ORDINANCE NO 2020-11

AN ORDINANCE TO REZONE AND ADOPT THE PRELIMINARY MASTER DEVELOPMENT PLAN FOR THE DISTRICT BEING LOCATED AT 108 STONEY CREEK ROAD, MAP 072P, PARCEL 028.00, 028.01, 028.02, 028.03 AND 028.04, IN THE CITY OF MT. JULIET, WILSON COUNTY, TN.

MEMORANDUM

Re: The District (Formerly Stoney Creek Town Center)
PMDP
Map – 72P
Parcel- 28.00

The District- PMDP Exhibit A

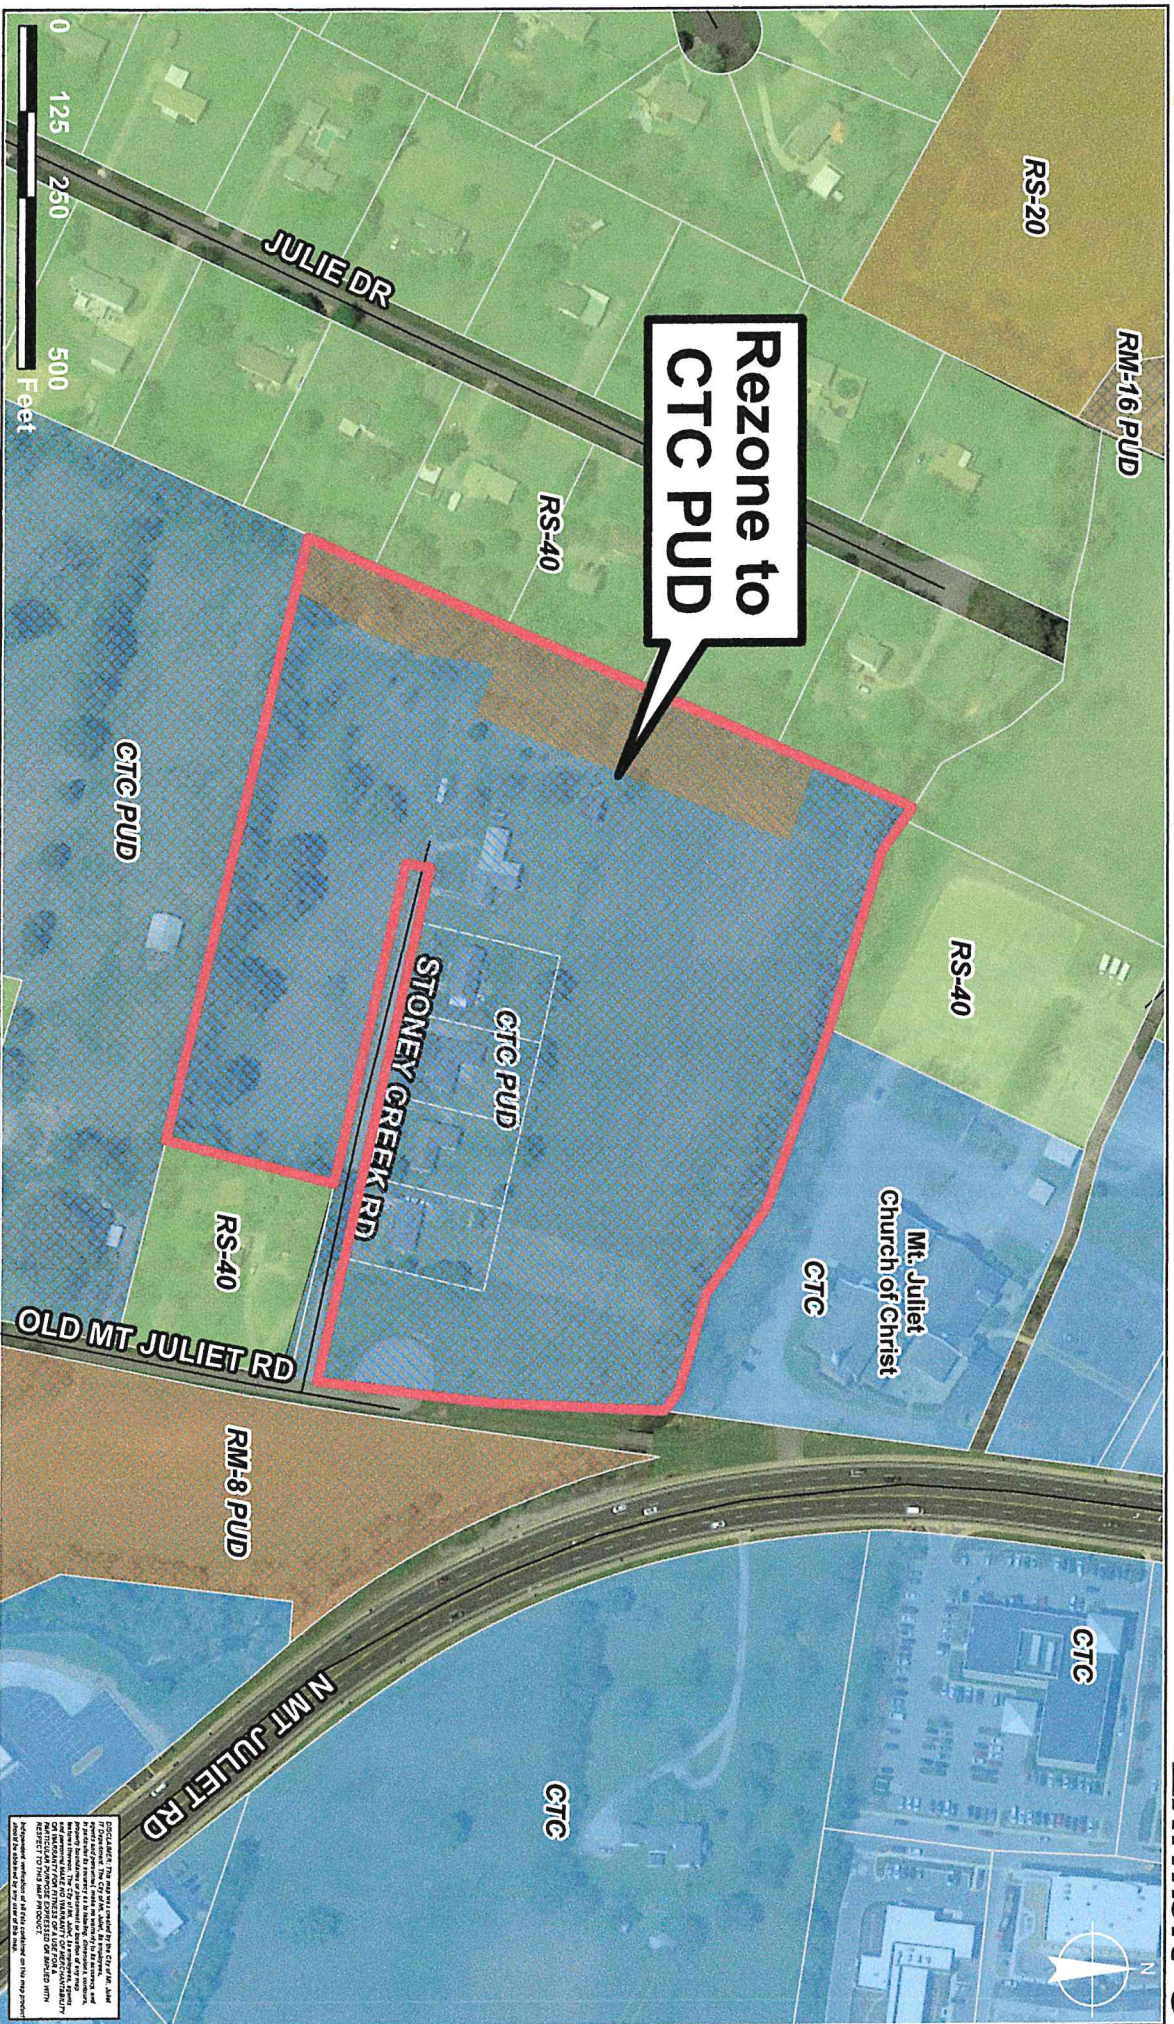
1. All Planning/Zoning comments are to be addressed before 1st Board of Commissioners meeting.
2. Staff does not recommend the layout for Units 62-74, 6-11 3, 30, 14, 14, 50, 51. Staff requests that a 22' driveway be provided for these units or on street parking in close proximity to the unit.

3. Clarify setbacks. The site data table and typical lot details do not match.
4. Correct the land use information in the table on C2-00.
5. The Planning Commission grants approval of the requested variances: 1.) to eliminate the required landscape buffer fence in the floodplain and; 2.) to permit a veterinary service on a lot which adjoins residential uses.

6. Provide elevations of all four sides of the proposed structures, including the clubhouse, mail kiosk, and commercial building.
7. All structures shall comply with the City's design guidelines.

8. All dumpster enclosures shall comply with the City's dumpster ordinance.
9. Should the units in the development not be individually owned, they shall comply with the City's multi-family development standards. No person or company shall own more than

11. Utility meters shall be screened with bricked wall from public view (see Bridgemill development for reference).
 12. No wooden fencing shall be permitted. Alternative material shall be submitted with the FMDP.

13. Commercial building shall be completed and operational before the 8th Certificate of Occupancy is issued for the townhomes.
 14. Mail kiosk shall be placed under a covered structure and be well lit.

15. Residential driveways shall be a minimum of 22' in length between the garage door and the sidewalk.
 16. A tree preservation plan shall be provided, including a minimum of 20' no disturbance buffer around the entire perimeter of the site. In those areas, supplemental plantings can be installed to meet the intent of the Transitional Protective Yard requirements, including the required fence.

17. Provide a phasing plan.
 18. Provide landscaped screening around stormwater features. This will be further discussed with FMDP.
 19. Commercial design standards shall be adhered to.

20. Label trailhead parking onsite with decorative signage.
 21. Work with Mt. Juliet Church of Christ to provide sidewalk section connecting Mt. Juliet Church of Christ greenway to N Mt. Juliet Road to improve connectivity in area. This will be a route heavily used by pedestrians to get to train station and future commercial sites.

1. Stoney Creek Road shall be constructed to the City's Access Street standard with a 50 foot ROW.
2. Stoney Creek Road between Old Mt. Juliet Road and the roundabout shall be a public street. All other proposed streets shall be private.

3. Anywhere there is proposed perpendicular parking (18 foot parking stalls) the drive aisle shall be a minimum of 25 feet wide.
4. All 2 way traffic aisles to be a minimum of 22' wide.

5. When parking is adjacent to the sidewalk, sidewalk to be 7' wide minimum.
6. The developer has agreed to the following off-site improvements:
 - a. 5 foot wide sidewalk along the west side of Old Mt. Juliet Road from this site to Old Lebanon Dirt Road.

7. Provide a 20' wide public access easement for the greenway.
8. Provide an updated sewer availability letter.
9. Fences in the floodplain should be designed so that they do not inhibit the flow of water.

1. There are no proposed water lines shown.
2. WWUD will serve.
3. Offsite improvements may require additional offsite water line work.
